State of New Mexico  
 Energy, Minerals and Natural Resources

WELL API NO. 30-015-25804
5. Indicate Type of Lease STATE <input checked="" type="checkbox"/> X FEE
6. State Oil & Gas Lease No. V-640
7. Lease Name or Unit Agreement Name STATE 2
8. Well Number 2
9. OGRID Number 4323
10. Pool name or Wildcat SHUGART YATES 7-RIVERS QN-GB
11. Elevation (Show whether DR, RKB, RT, GR, etc.) 3,523.7" GR

SUNDRY NOTICES AND REPORTS ON WELLS  
 (DO NOT USE THIS FORM FOR PROPOSALS TO DRILL OR TO DEEPEN OR PLUG BACK TO A DIFFERENT RESERVOIR. USE "APPLICATION FOR PERMIT" (FORM C-101) FOR SUCH PROPOSALS.)

**CONDITIONS OF APPROVAL FOR PLUGGING & ABANDONMENT**

# Current Wellbore Schematic

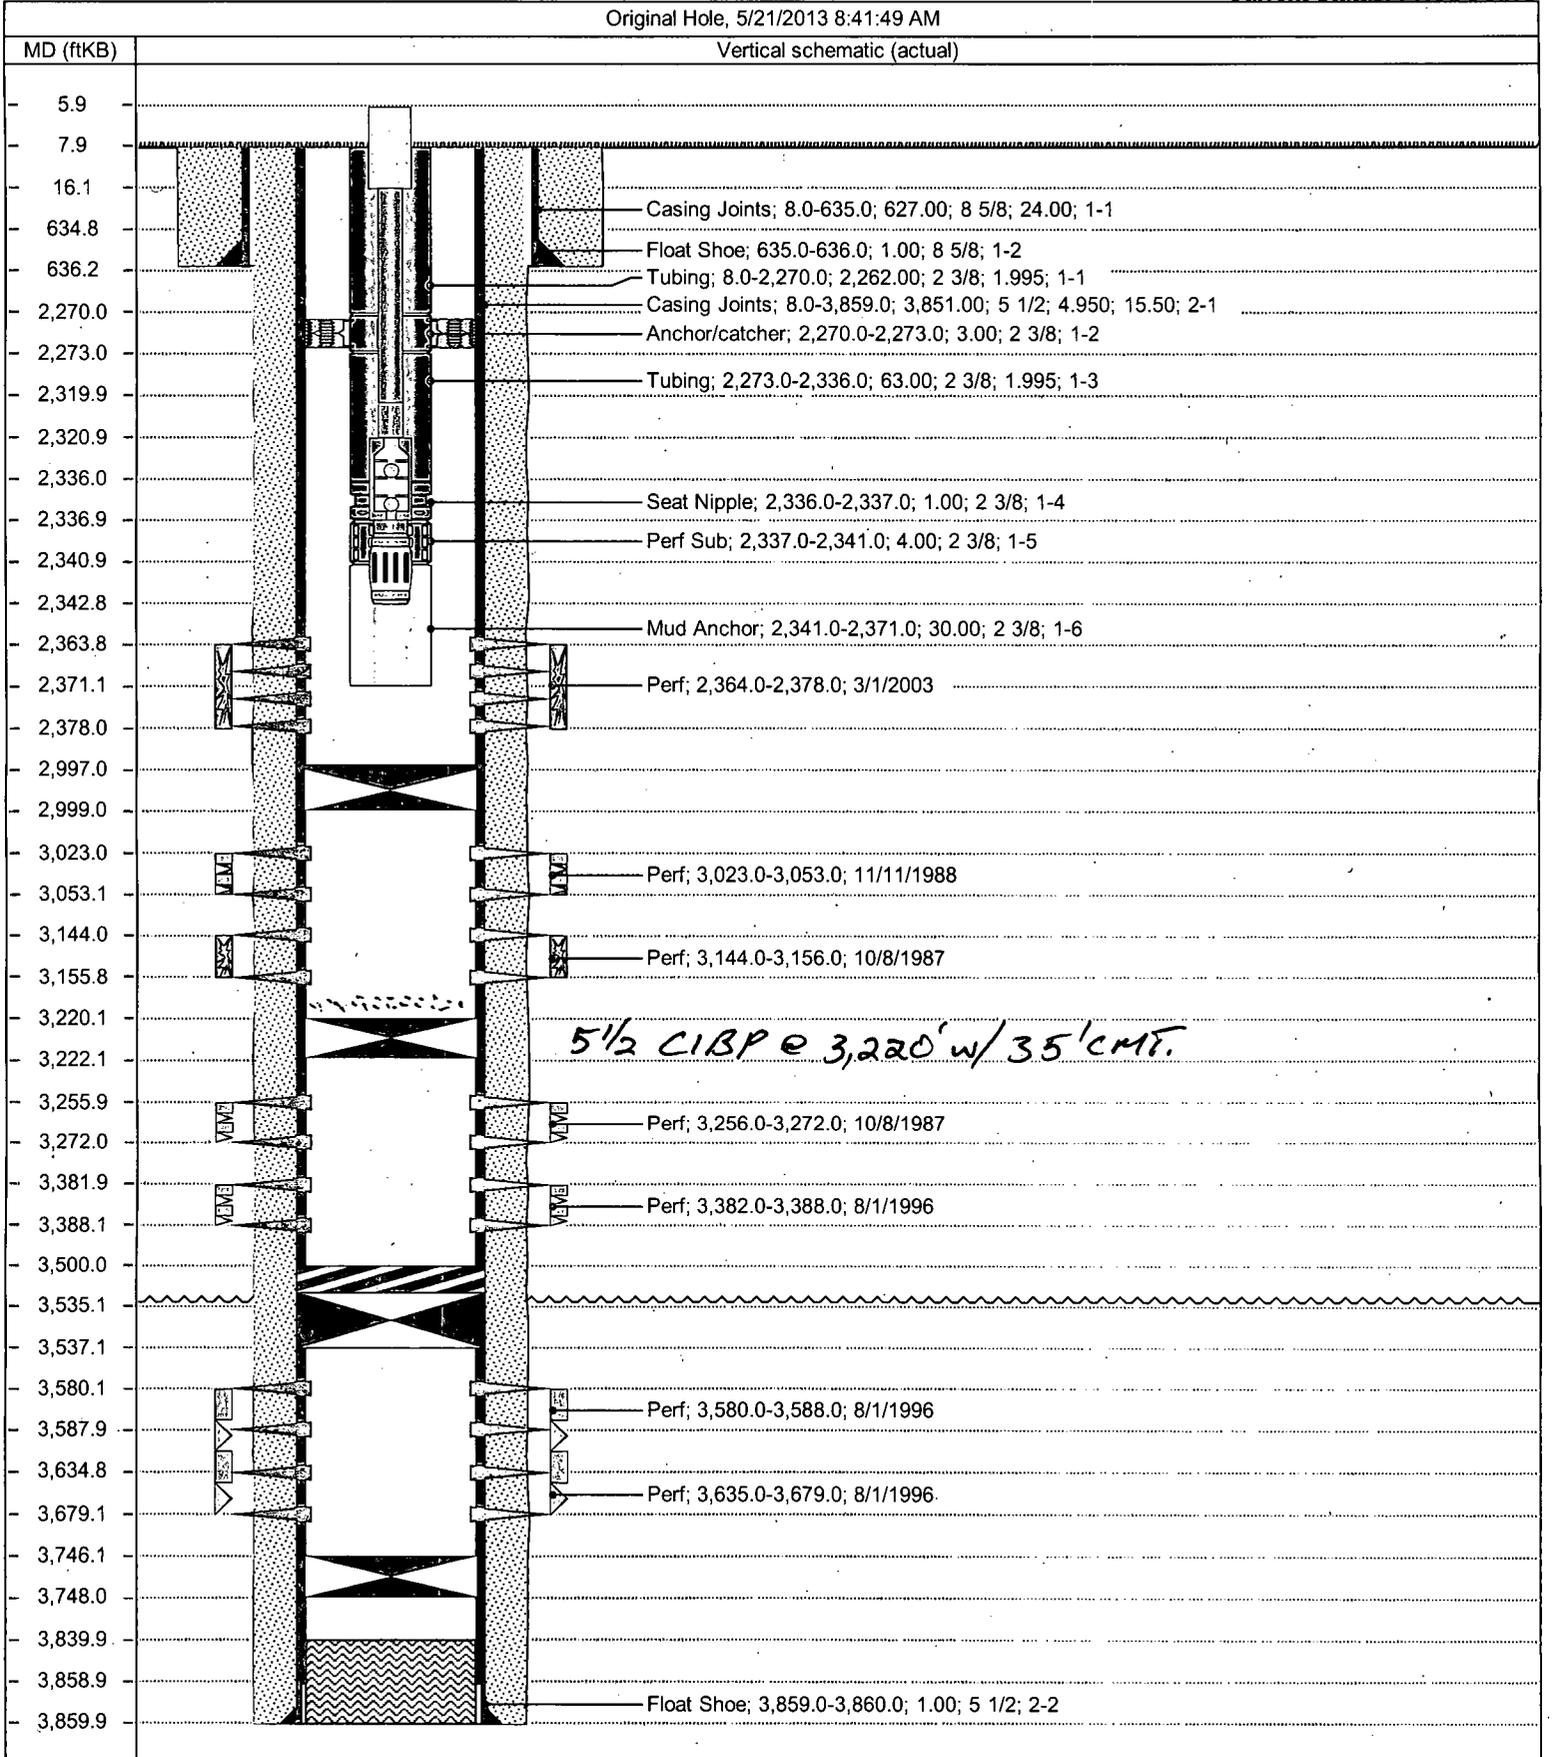
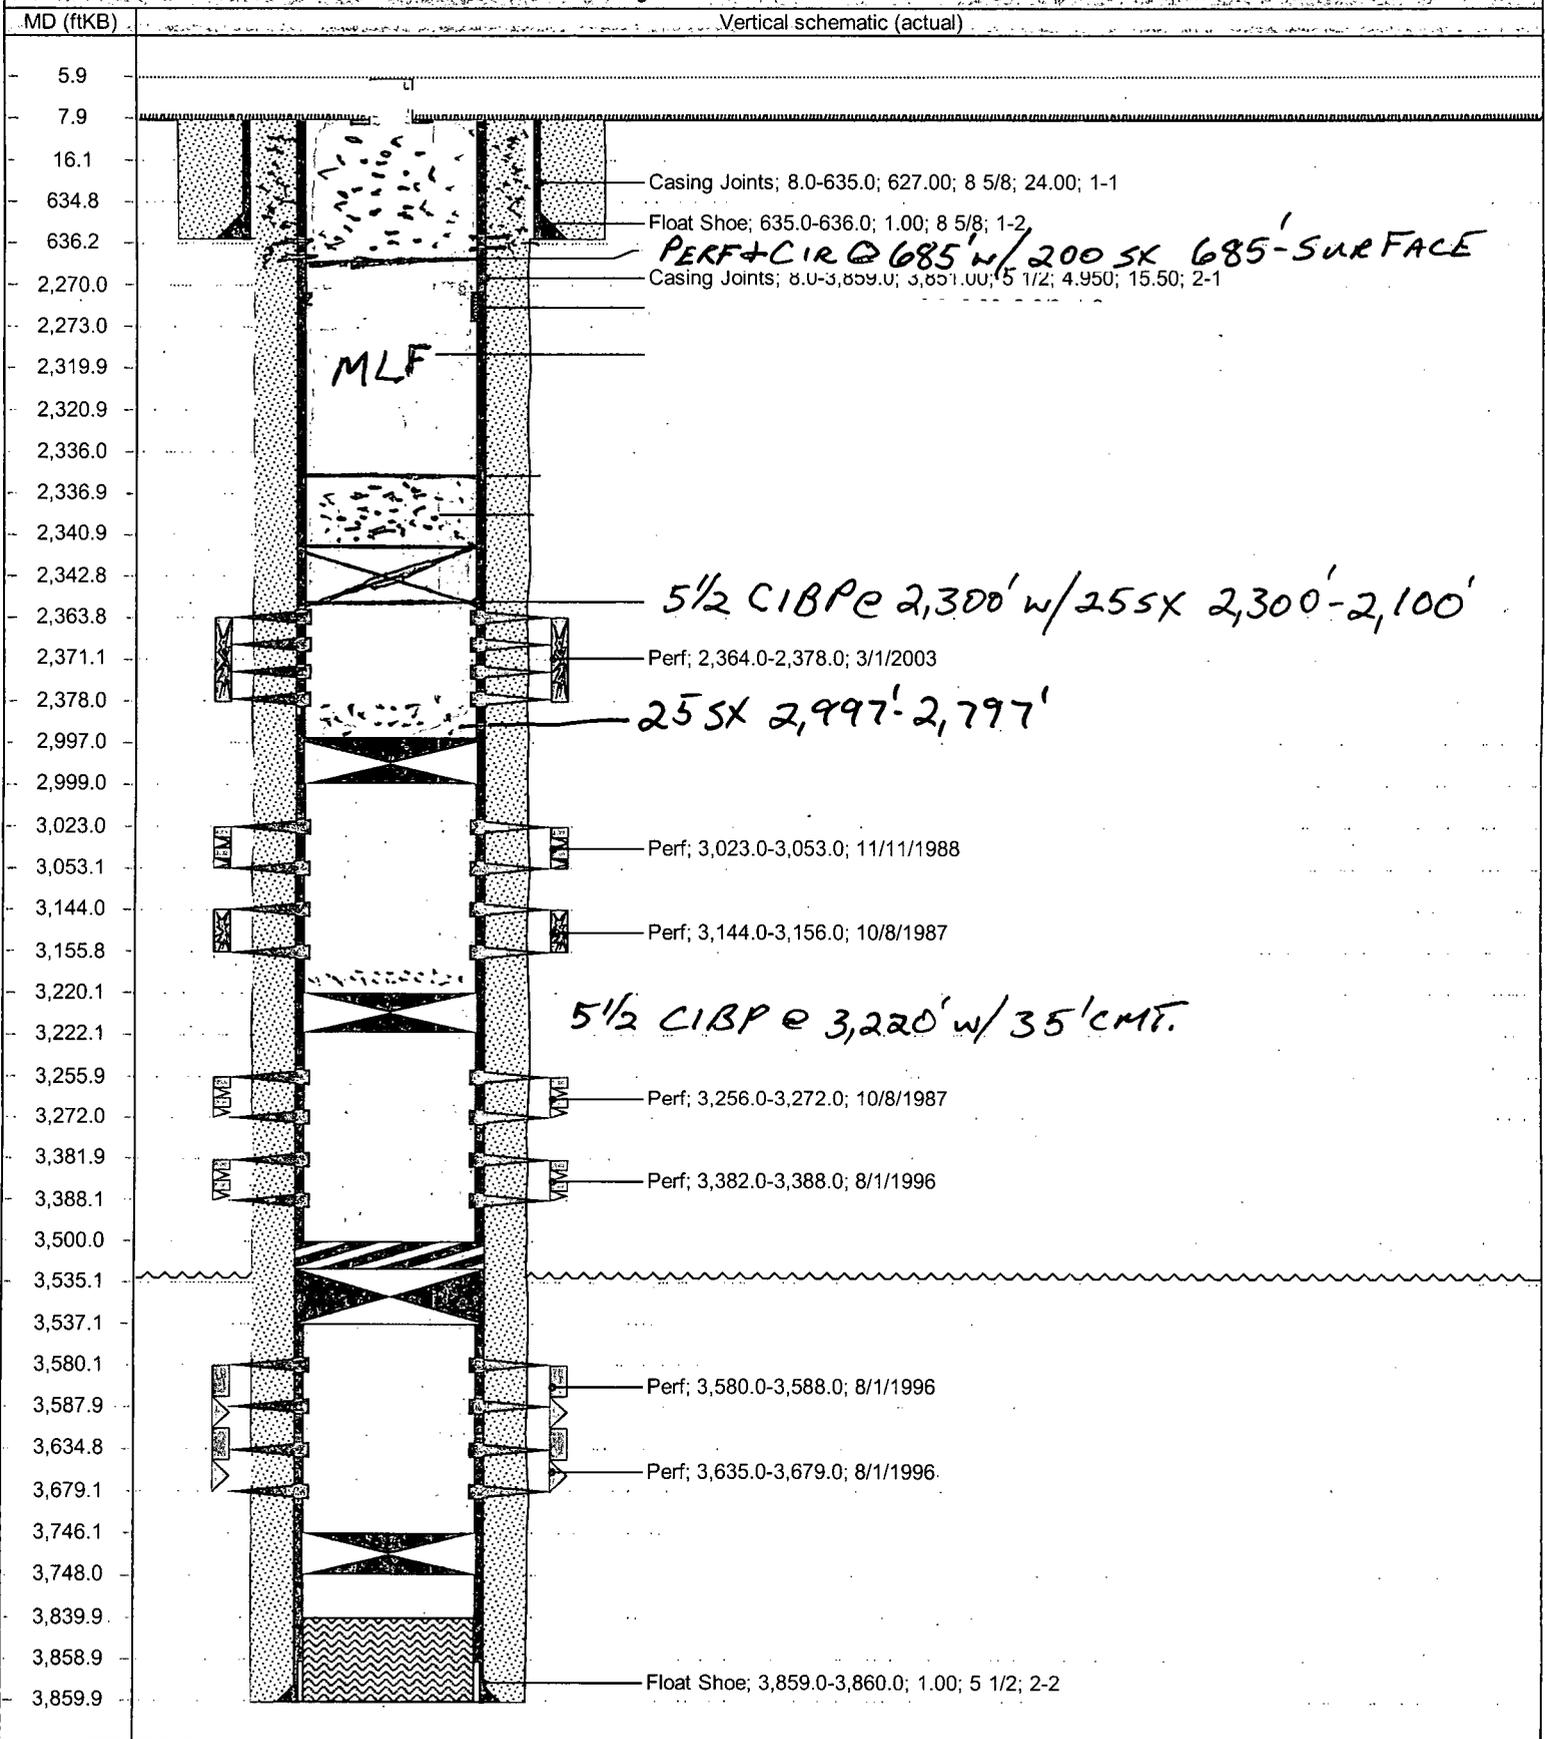
13. Describe proposed or completed operations. (Clearly state all pertinent details, and give pertinent dates, including estimated date of starting any proposed work). SEE RULE 19.15.7.14 NMAC. For Multiple Completions: Attach wellbore diagram of proposed completion or recompletion. **8 5/8" -636' TOC SURFACE, 5 1/2" -3,860' TOC SURFACE, PERFS 2,364'-2,378' CIBP's @ 3,535', 3,220', 2,997' W/ 35' CMT. ON EACH**

AS EARLY AS MAY, 18, 2015 MOVE IN & RIG UP, RIH TO 2,997', MIX & SPOT 25 SX CL "C" CEMENT FROM 2,997'-2,797'.  
 POOH, PU & RIH W/ 5 1/2" CIBP SET @ 2,300', CIR W/ 9.5# SALT GEL.  
 MIX & SPOT 25 SX CL "C" CEMENT FROM 2,300'-2,100'.  
 PULL UP TO 600', RIG UP WIRELINE, RIH PERF @ 685', EST CIR. UP 8 5/8", POOH, RD W/L UNIT.  
 MIX & CIR. 200 SX CL "C" CEMENT TO SURFACE ON BOTH STRINGS. POOH W/ TBG. NIPPLE DOWN CUT & CAP WELL TO MEET WITH RULE 19.15.7.14 NMAC REQUIRMENTS.  
**CLASS "C" CEMENT & CLOSED LOOP SYSTEM TO BE USED.**

Approved for plugging of well bore only.  
 Liability under bond is retained pending receipt of C-103 (Subsequent Report of Well Plugging) which may be found at OCD Web Page [www.cmnrd.state.nm.us/oed](http://www.cmnrd.state.nm.us/oed).

\*Plugging must be done by 5/8/2016

1. Produced water **will not** be used during any part of the plugging & abandonment operation.
2. Notify NMOCD Dist. 2 office at least 24 hrs before beginning work.

3. Closed Loop System is to be used for entire plugging operation. Upon completion, contents of steel pit are to be hauled to a permitted disposal location.

7. Every attempt must be made to clean the well bore out to below the perms, before any plugs can be set, by whatever means possible.
8. **Cement Retainers may not be used.**

9. **Squeeze pressures are not to exceed 500 PSI, unless approval is given by NMOCD.**
10. **Plugs may be combined after consulting with and getting approval from NMOCD.**

11. **Minimum WOC time for tag plugs will be 4 Hrs.**
